University Avenue Mobility Plan

Final Environmental Impact Report
SCH No. 2010031029; Project No. 115295

RESPONSE TO COMMENTS

**LIST OF PERSONS, ORGANIZATIONS, AND PUBLIC AGENCIES THAT
COMMENTED ON THE DRAFT ENVIRONMENTAL IMPACT REPORT (EIR)**

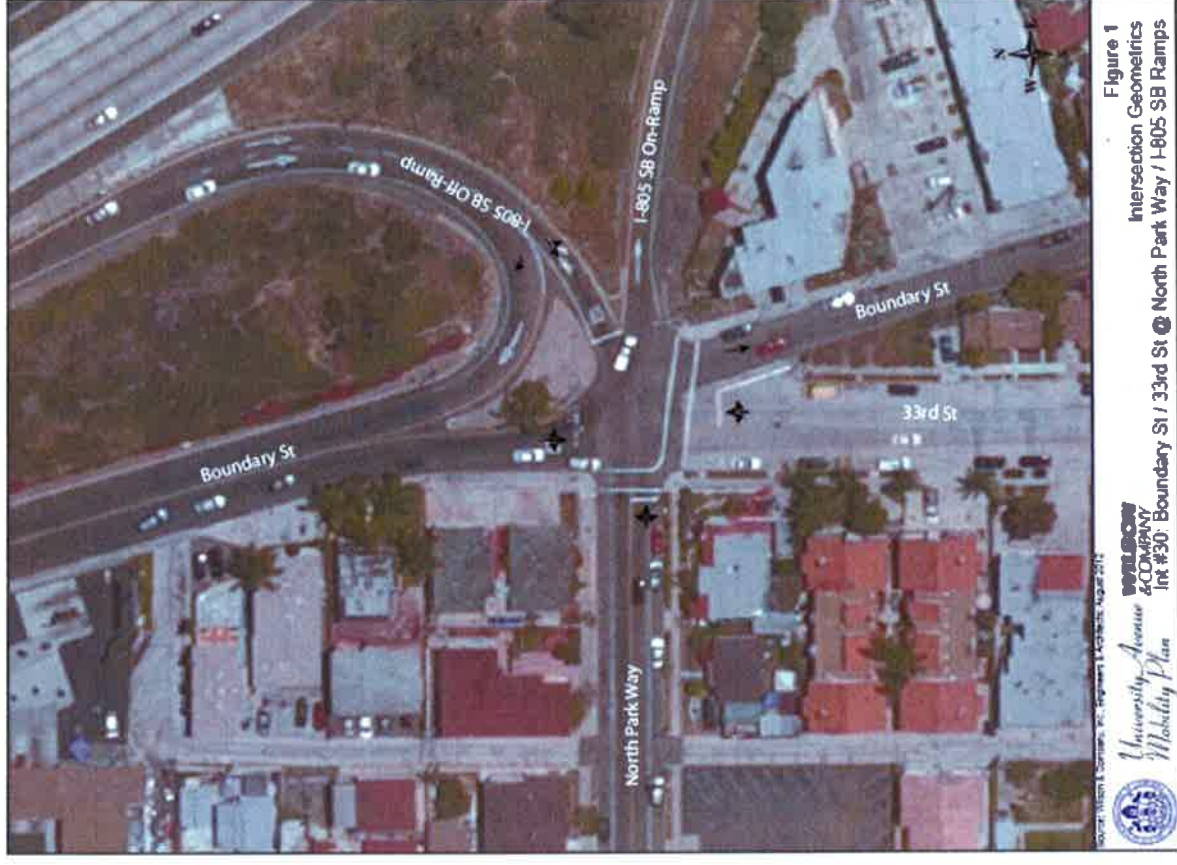
- Provide layout with striping and signage. What is the signal and lane configuration used for Table 4-3 mitigated 69.1 delay?
- Provide a queue analysis of the SB I-805 exit ramp to North Park Way.
- A signal warrant analysis will be required. Signal warrants shall be done per the California Manual on Uniform Traffic Control Devices (MUTCD). The decision to install a signal should not be based solely upon the warrants since the installation of traffic signals may increase certain types of collisions. Delay, congestion, approach conditions, driver confusion, future land uses or other evidence of the need for right-of-way assignment beyond that which could be provided by stop signs must be demonstrated.

B3 Consistent with your comment, the Draft EIR concludes that the project would result in significant direct and cumulative impacts to the intersection of North Park Way/I-805 southbound (SB) Ramps/Boundary Street during the PM peak period. The Draft EIR also identifies mitigation (Mitigation Measure 5.2-1) that would reduce project impacts to below a level of significance, which involves installation of a traffic signal at this intersection. Regarding the request for additional information for the North Park Way/I-805 SB Ramps/Boundary Street intersection impacts, the following information is provided:

- The lane configuration used in Table 4-3 of the Existing Plus Project Conditions Report (EIR Appendix C) remained the same as Existing Conditions, except for the installation of a traffic signal. See Figure 1 below.
